Product Change Notification / ASER-23WWAI681

CCB 4235 Final Notice: Qualification of MMT as a new final test site for selected Atmel AT27C/BV/LVxxxPU/JUxxx products

PCN # ASER-23WWAI681
CCB 4235_Pre and Post Change Summary

PLCC 32 CARRIER TAPE

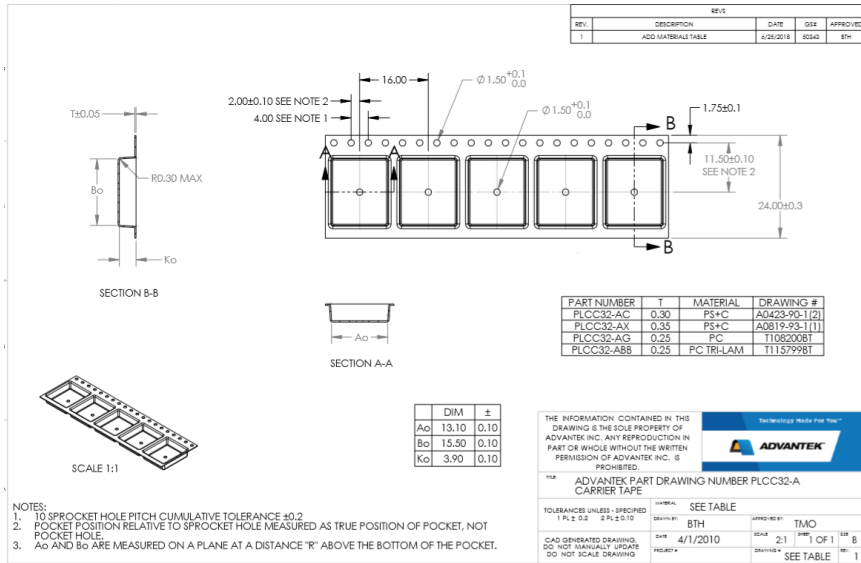
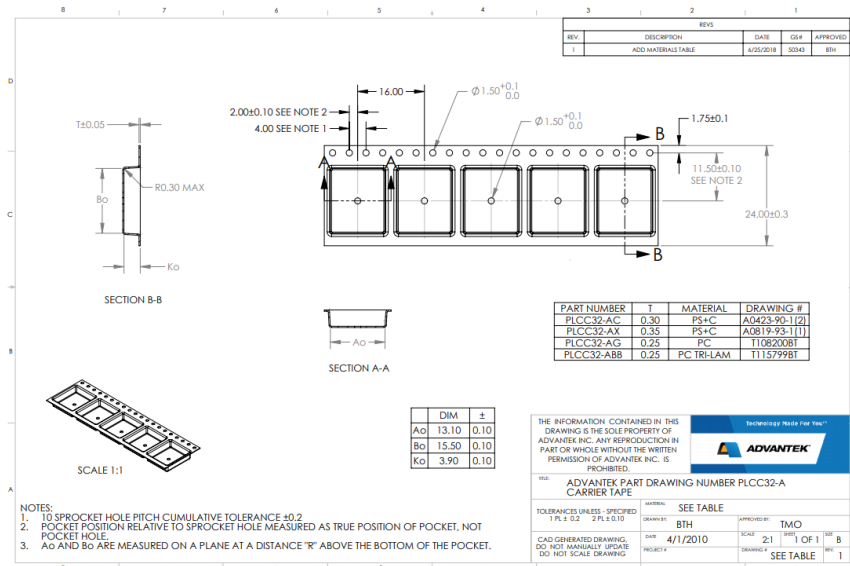
Supplier	Mfg. Part No.	W (mm.) ±0.3 or Specific	P (mm.) ±0.1 or Specific	A ₀ ±0.1 or Specific	B ₀ ±0.1 or Specific	K ₀ ±0.1 or Specific	Thickness
Advantek	PLCC32-AC170.M1	24	16	13.10/-0.1	15.50+/-0.1	3.90+/-0.10	0.30 +/-0.05

PLCC 44 CARRIER TAPE

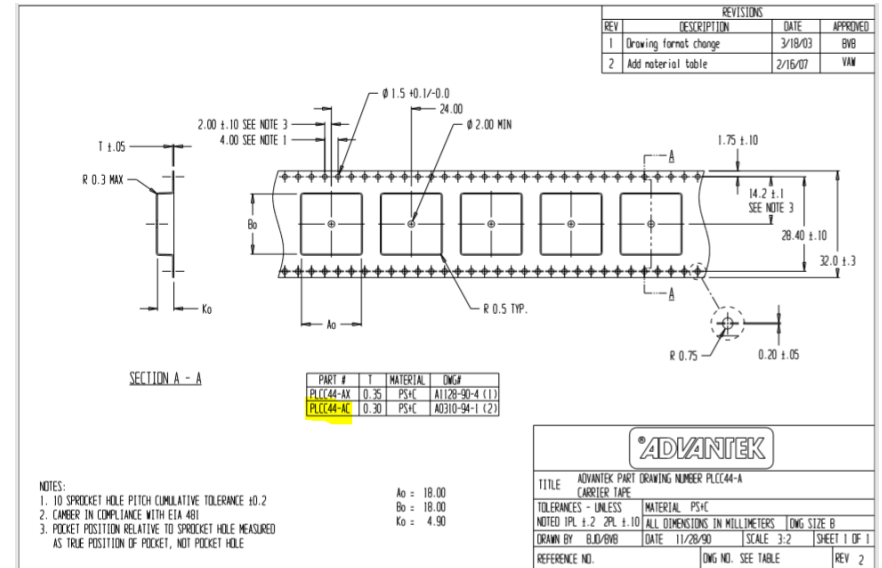
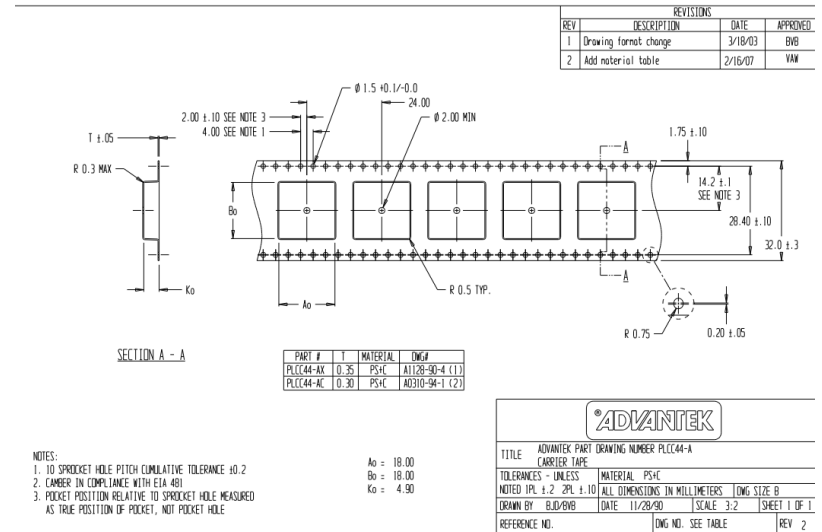
Supplier	Mfg. Part No.	W (mm.) ±0.3 or Specific	P (mm.) ±0.1 or Specific	A ₀ ±0.1 or Specific	B ₀ ±0.1 or Specific	K ₀ ±0.1 or Specific	Thickness
Advantek	PLCC44-AC88.0R5	32	24	18+/-0.1	18+/-0.1	4.9+/-0.1	0.30 +/-0.05

PLCC 32 COVER TAPE (Width: 24mm)

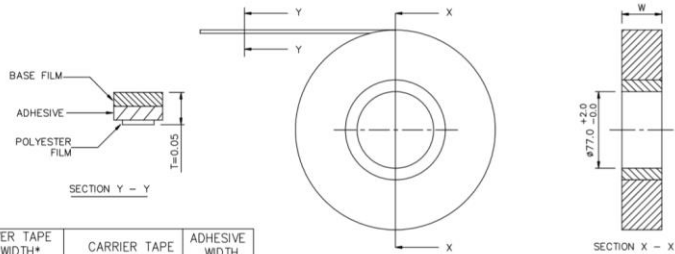
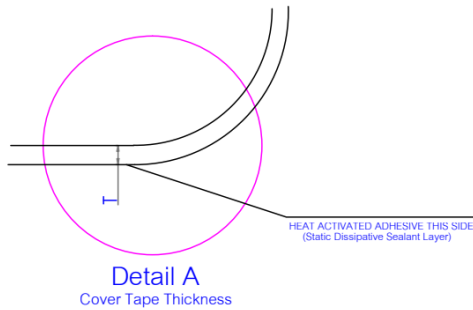
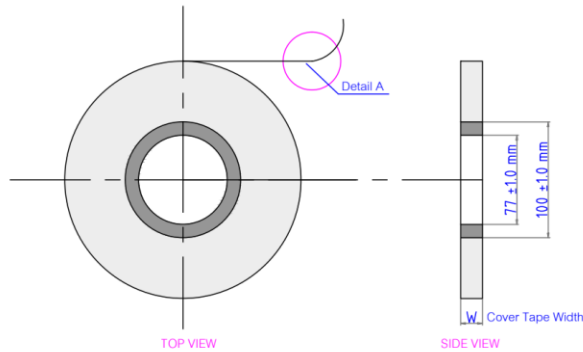
Carrier Width	Supplier	MCHP P/N	Supplier Part	Width "W" (mm)	Thickness (mm)	Sealing Mythology
24mm	CPak	211894	CP58 PSA	21.3 +/-0.1	0.050 ±0.010	Pressure Seal

Carrier Width	Supplier	MCHP P/N	Supplier Part	Width "W" (mm)	Thickness (mm)	Sealing Mythology
24mm	Sumitomo	22102002	CSL-Z7302	21.0 +/- 0.1	0.050 ±0.010	Heat Sealing

PLCC 44 COVER TAPE (Width: 32mm)

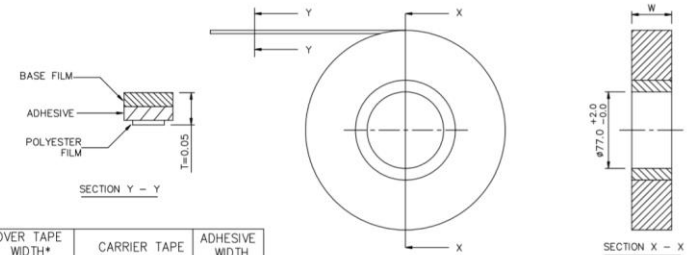
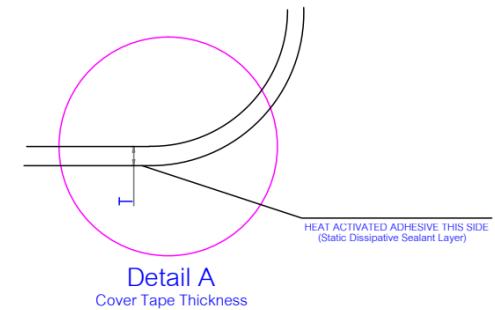
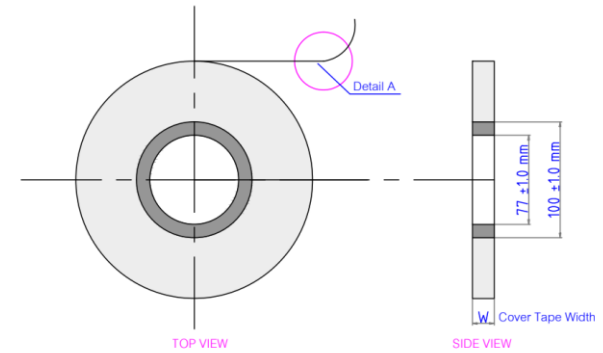
Carrier Width	Supplier	MCHP P/N	Supplier Part	Width "W" (mm)	Thickness (mm)	Sealing Mythology
32mm	CPak	211887	CP58 PSA	25.5 +/-0.1	0.050 ±0.010	Pressure Seal

Carrier Width	Supplier	MCHP P/N	Supplier Part	Width "W" (mm)	Thickness (mm)	Sealing Mythology
32mm	Sumitomo	22104401	CSL-Z7302	25.5 +/- 0.1	0.050 ±0.010	Heat Sealing

PLASTIC REEL: WIDTH 24mm

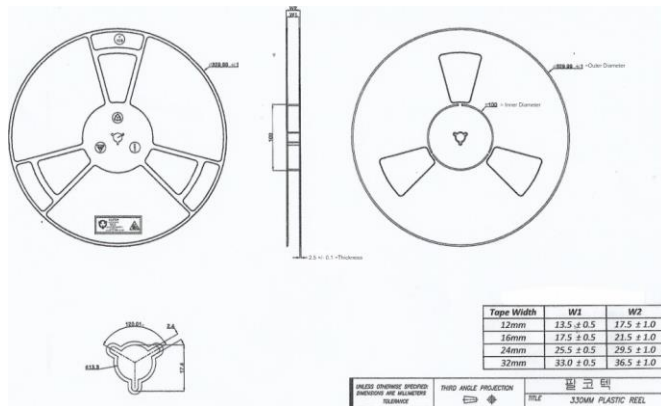
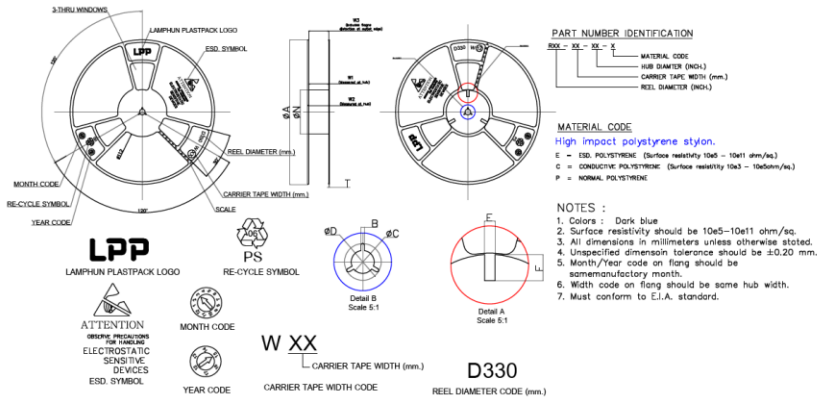
Width	MCHP P/N	Supplier Part	Hub	Color
24mm	211696	N/A	4inch (100mm)	White

Width	MCHP P/N	Supplier Part	Hub	Color
24mm	23000024	R13-24-04-E	4inch (100mm)	Dark Blue

Description	MPHIL	MMT
Color	White	Dark blue
Diameter	329.99 +/- 1.0	330 +/- 2.0
Hub	100	100 +/- 2.0
Width	25.5 +/- 0.5	24.4 +/- 2.0

PLASTIC REEL: WIDTH 32mm

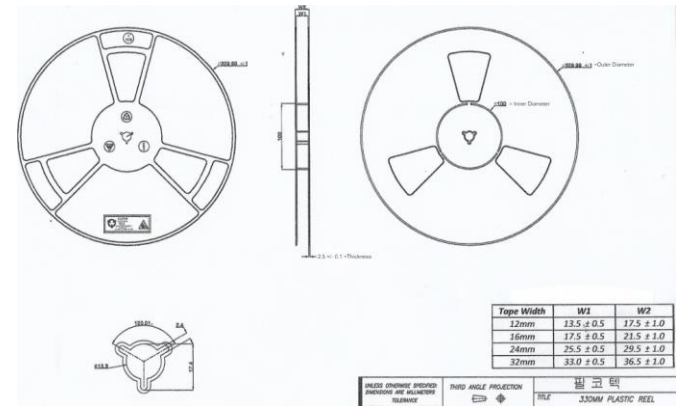
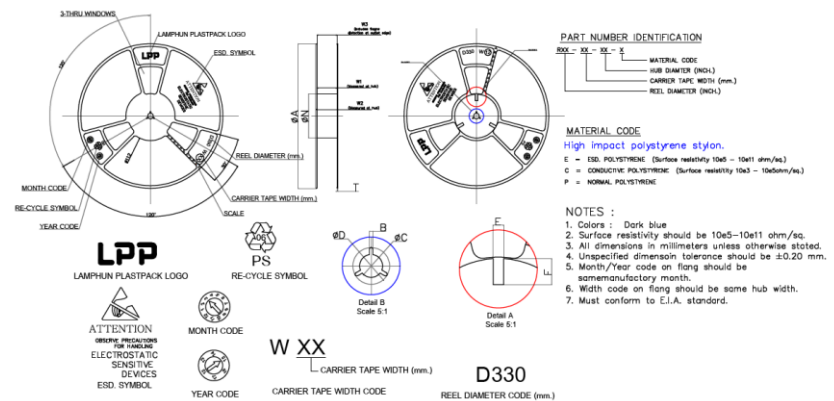
Width	MCHP P/N	Supplier Part	Hub	Color
32mm	211697	N/A	4inch (100mm)	White

Width	MCHP P/N	Supplier Part	Hub	Color
32mm	23000023	R13-32-04-E	4inch (100mm)	Dark Blue

Description	MPHIL	MMT
Color	White	Dark blue
Diameter	329.99 +/- 1.0	330 +/- 2.0
Hub	100	100 +/- 2.0
Width	33 +/- 0.5	32.4 +/- 2.0
